Re: Docket No. 40-8903
License No. SUA-1471
Up-date of Table 2 – Groundwater Monitoring Program (8-97)

TABLE 2 – Groundwater Monitoring Program (8-99)

**TREND ANALYSIS FIGURES
FOR
TABLE 2 MONITORING WELLS

Figure 19
Well 0846

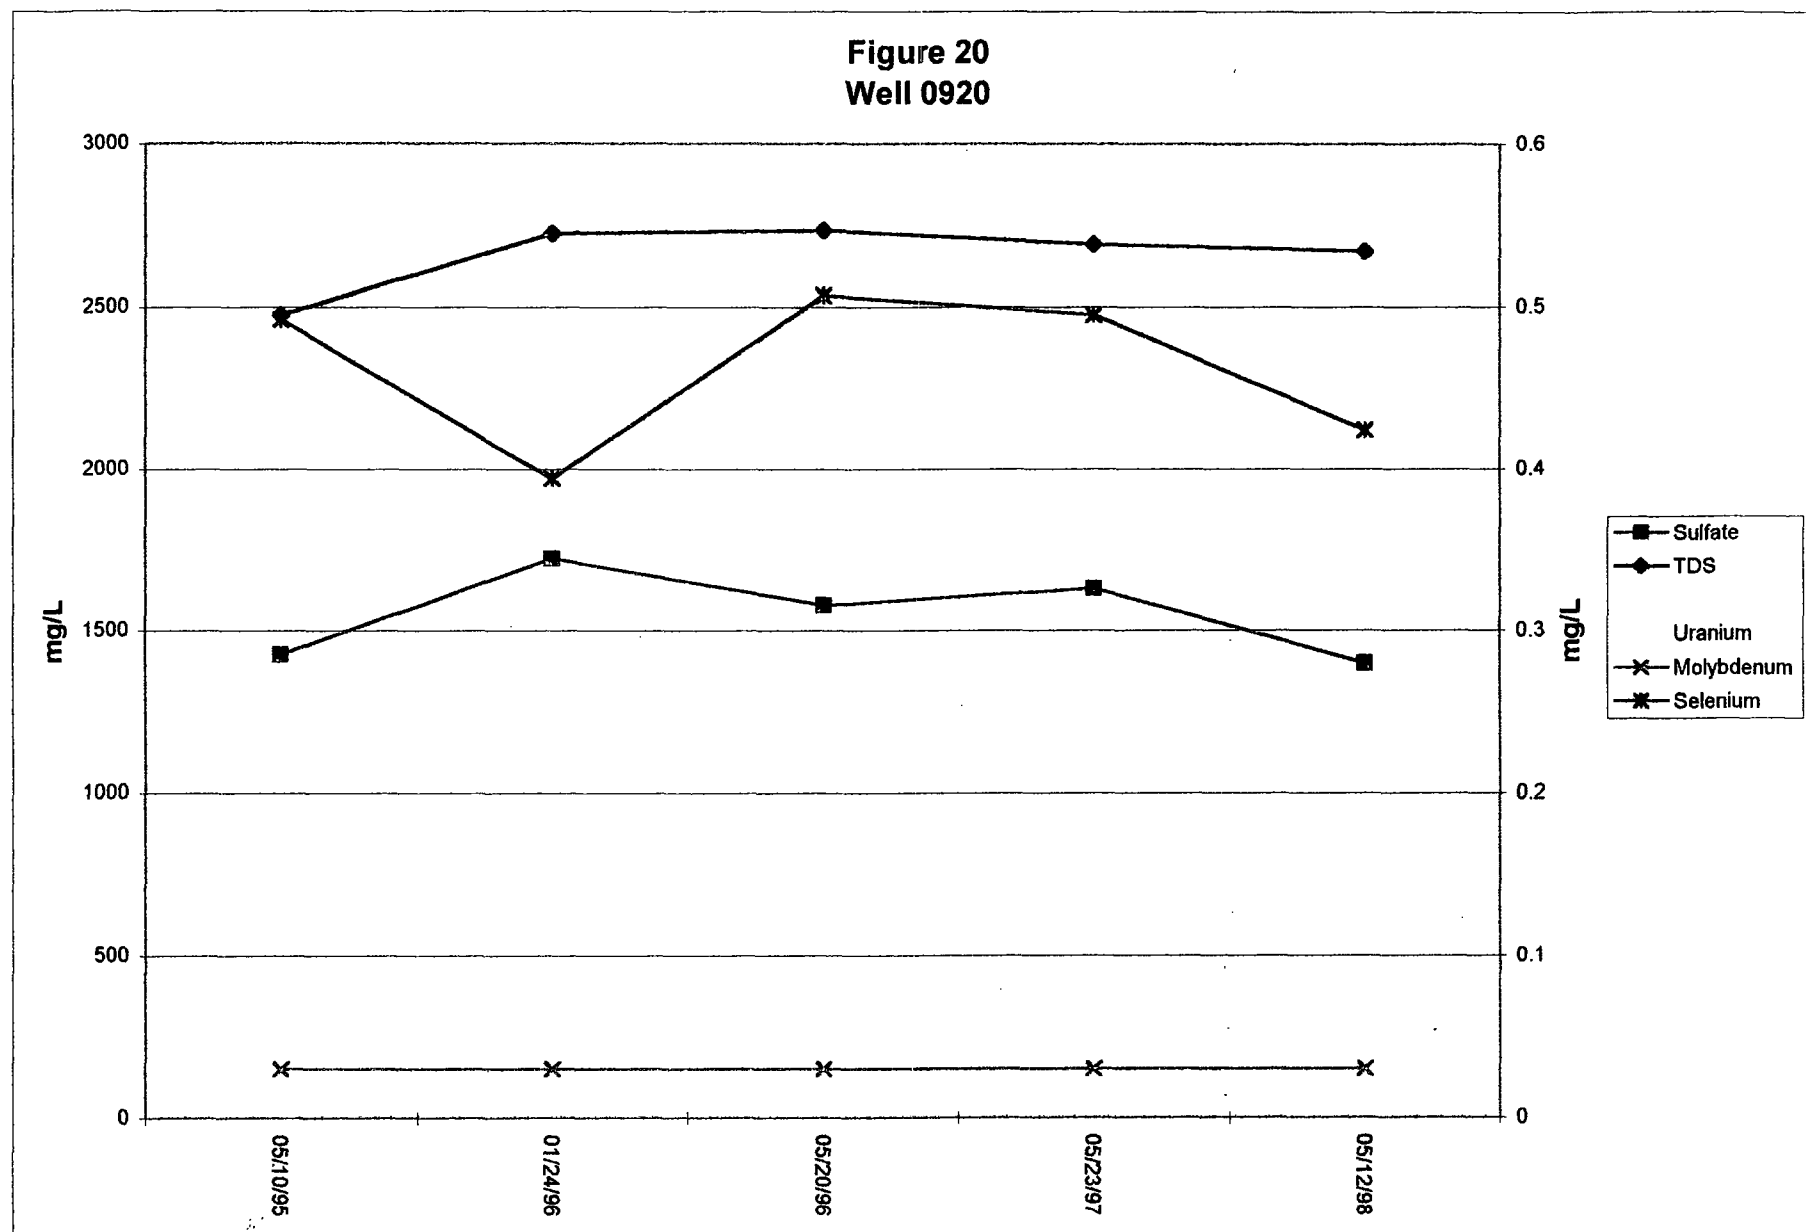
- Pleasant Valley –Well 688 and 846 will be monitored annually for the G list of parameters. The trend analysis for this well has shown that changes in concentrations are not seasonal and annual monitoring should be adequate (refer to Figure 18 and 19). Well 835 will be eliminated as a monitoring well. It is an old well on private property. The pump no longer works and we were not able to collect a sample in 1998. We feel that wells 688 and 846 will adequately monitor the Pleasant Valley area.

Figure 21
Well 0942

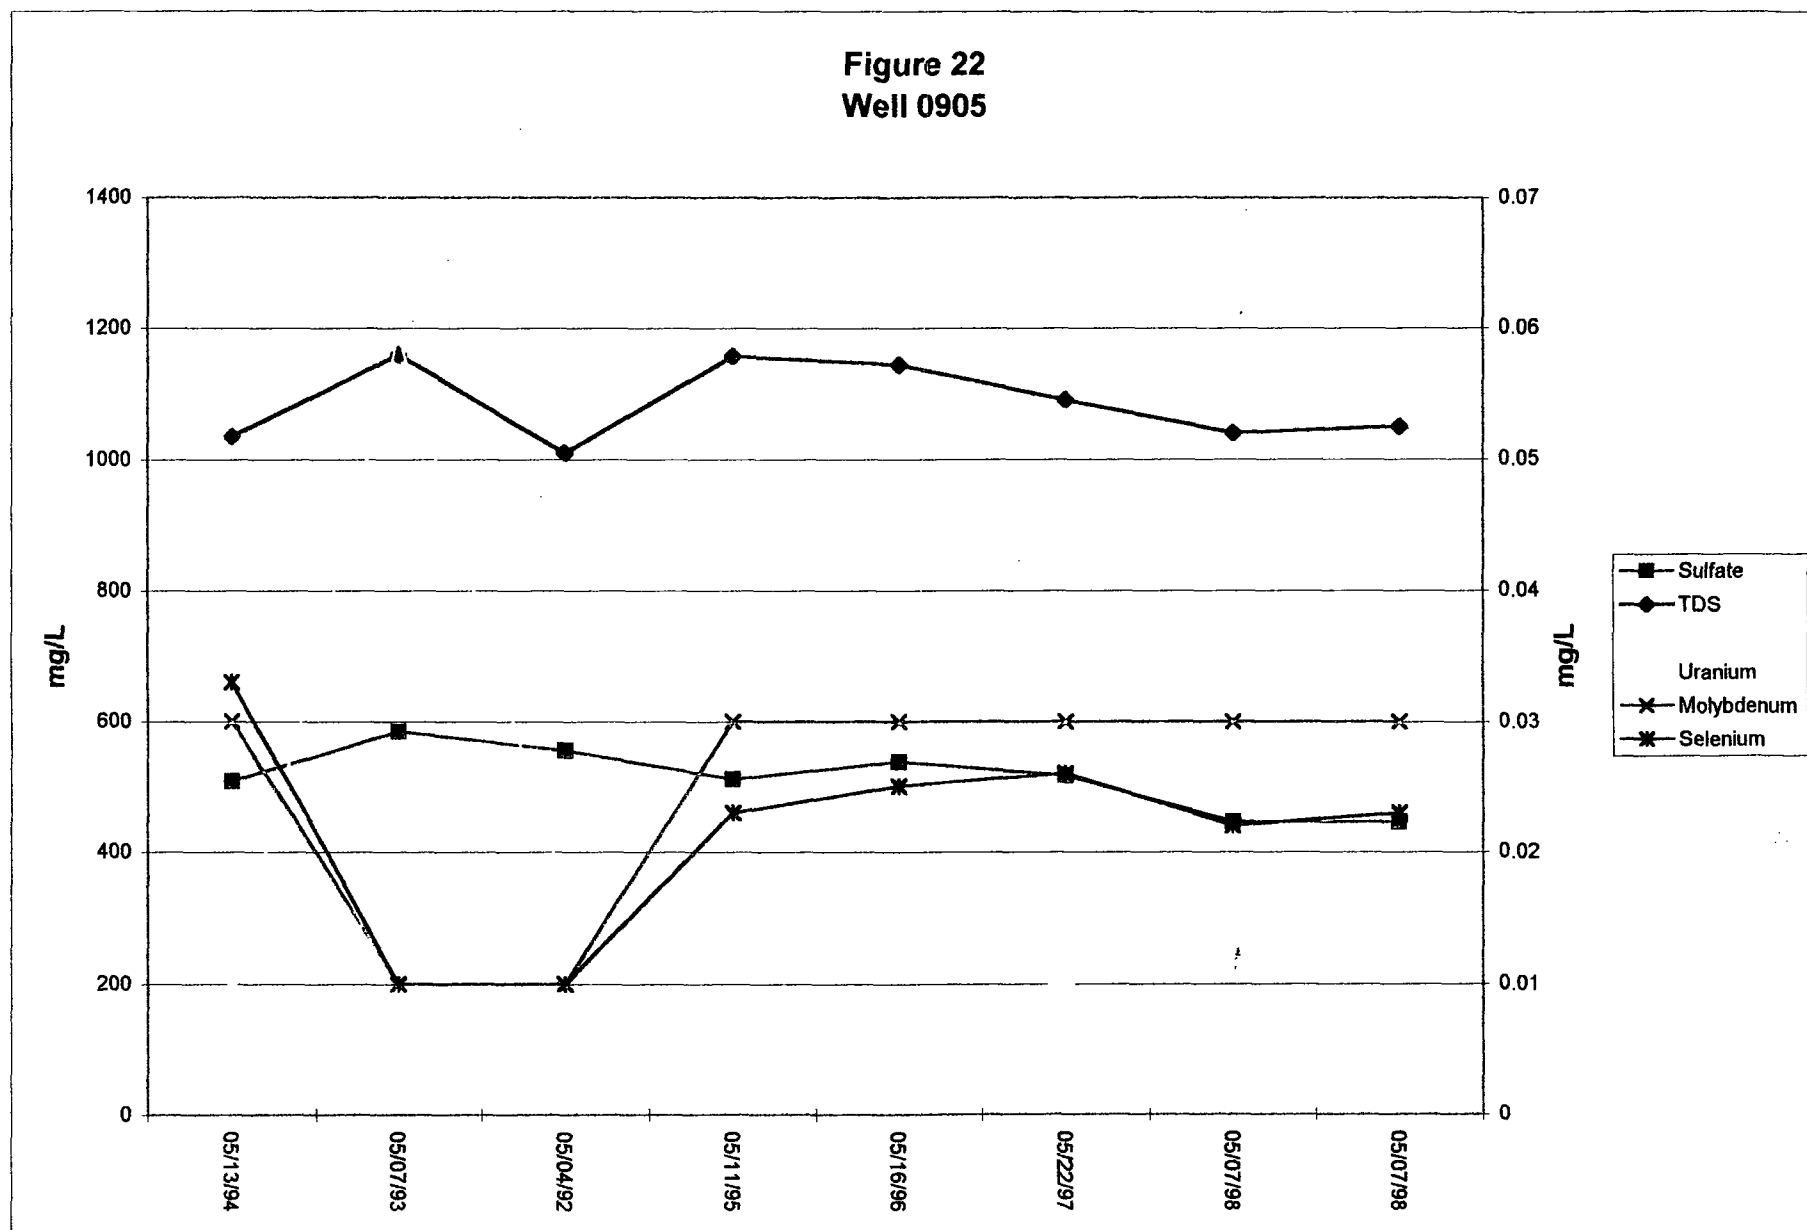
- Regional –Wells 920 and 942 will be monitored annually for the G list of parameters. The trend analysis for these wells has shown that changes in concentrations are not seasonal and annual monitoring should be adequate (refer to Figures 20 and 21). We are proposing to eliminate wells 905, 910 and 917 from the monitoring program. The trend analysis for these wells has shown that the concentration of contaminants has remained below site standards (refer to Figures 22, 23, and 24).
